# SUBSURFACE WASTEWATER DISPOSAL SYSTEM VARIANCE REQUEST

System's Location: 755 west River Road

# SUBSURFACE WASTEWATER DISPOSAL SYSTEM APPLICATION

SUBSURFACE WASTEWATER DISPOSAL PLAN

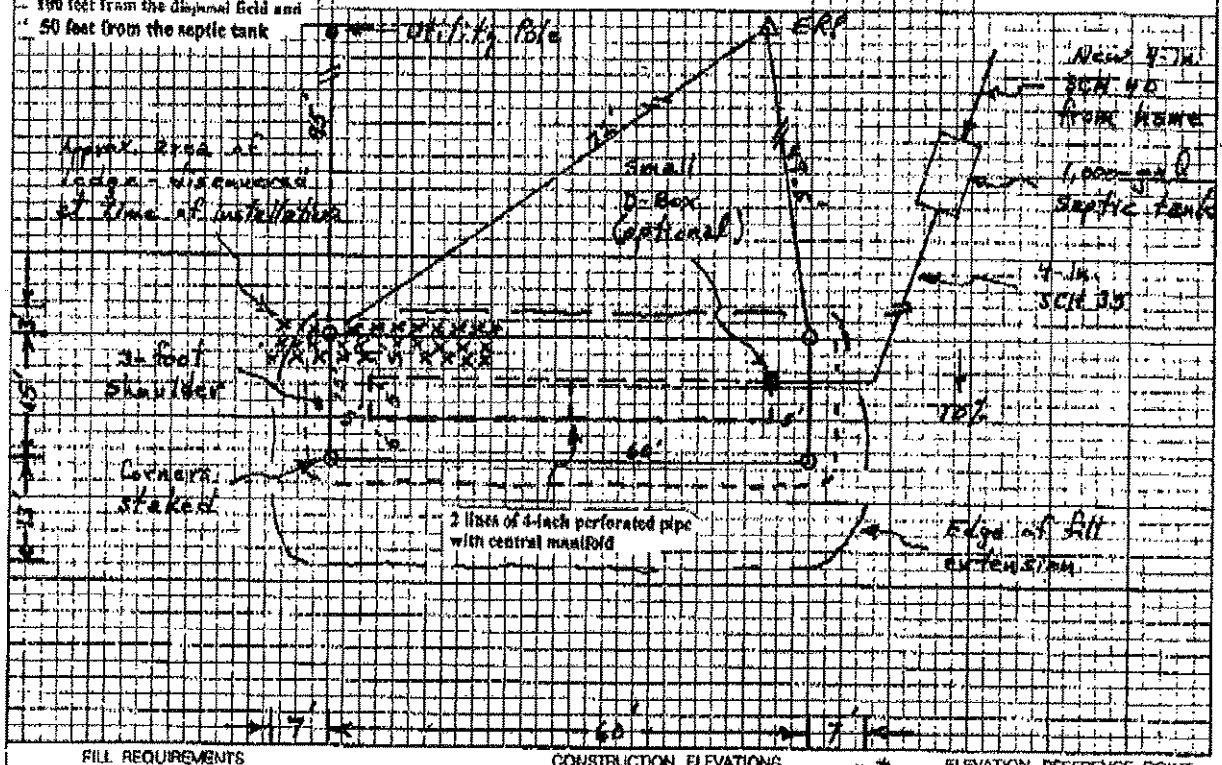
1. For a small section of the disposal bed reduce the — Table 4F in
2. separation between the bottom of the stone and the — Section 4
3. underlying bedrock to 14" rather than 24".

During the installation, an area of ledge was found to be about 24" below the surface. It effects the uphill edge of the bed for about 20 feet. Given the narrow window of good weather, it's best to ask for a variance of 10 inches of soil & continue to get the system in the ground & covered.

Finished Grade Elevation -55"

Top of Distribution Pipe or Proprietary Device -66"

Bottom of Disposal Area -78"
